Some Clause 95 comments

Pete Anslow, Ciena

IEEE P802.3bm Task Force, August 2013

ER limit – OMA / average

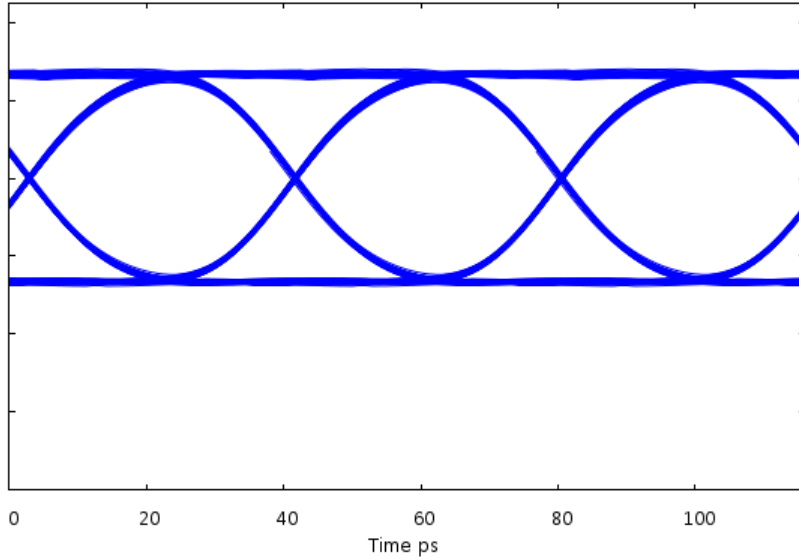
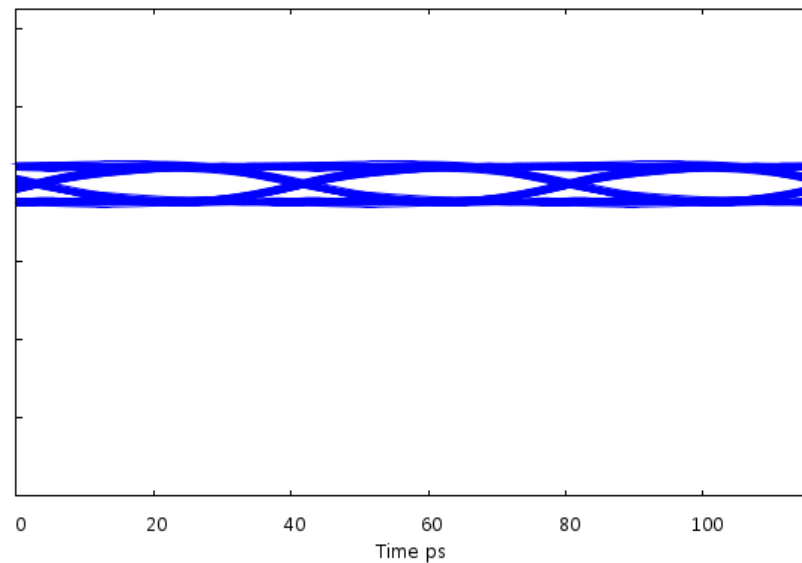
ER limit – ideal eyes

3 dB

2 dB

ER limit – eyes with ISI

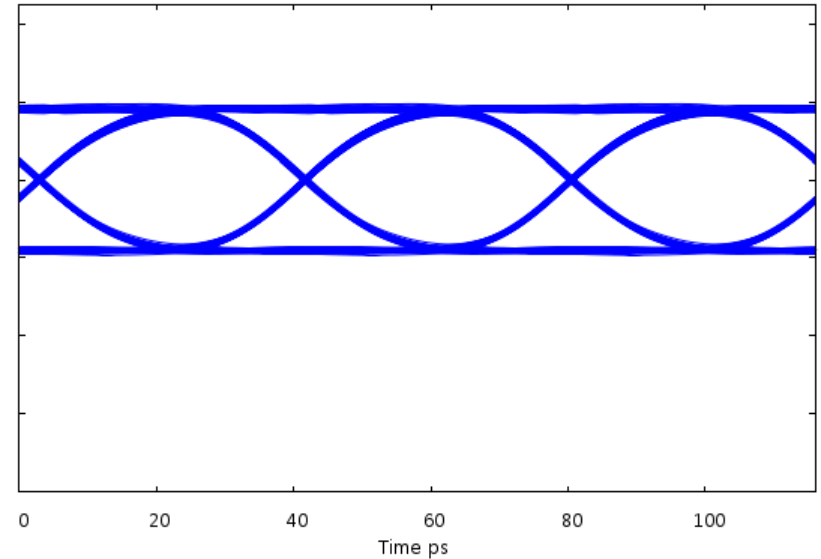
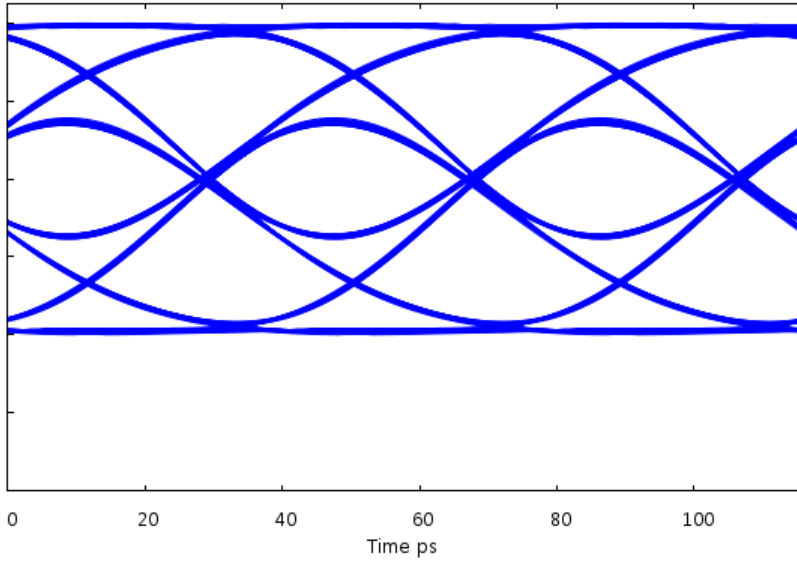
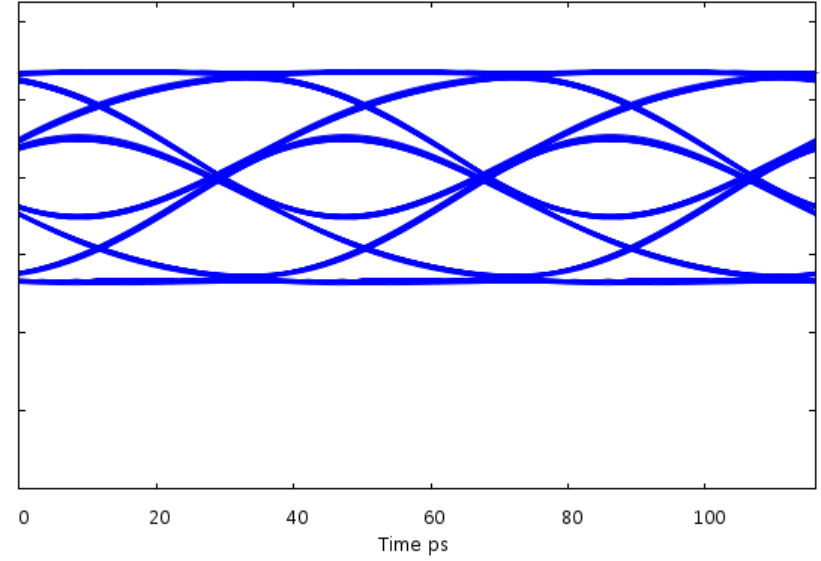
**No ER limit
Signal with
max Average
power and
min OMA**

3 dB

2 dB

No hits on eye mask

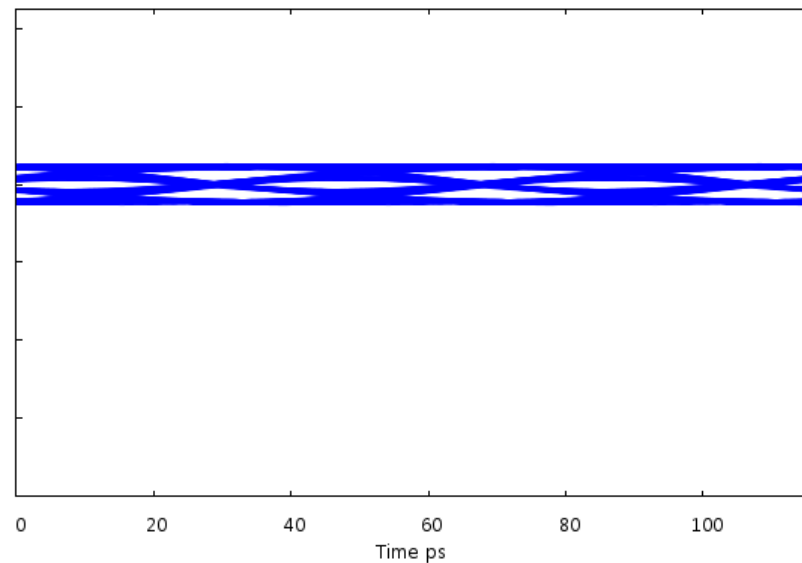
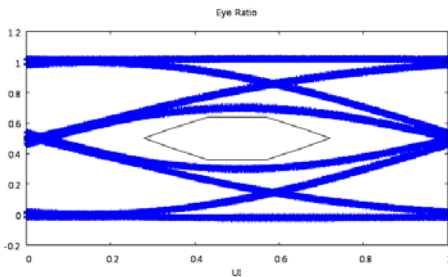
No ER limit
Signal with
max Average
power and
min OMA
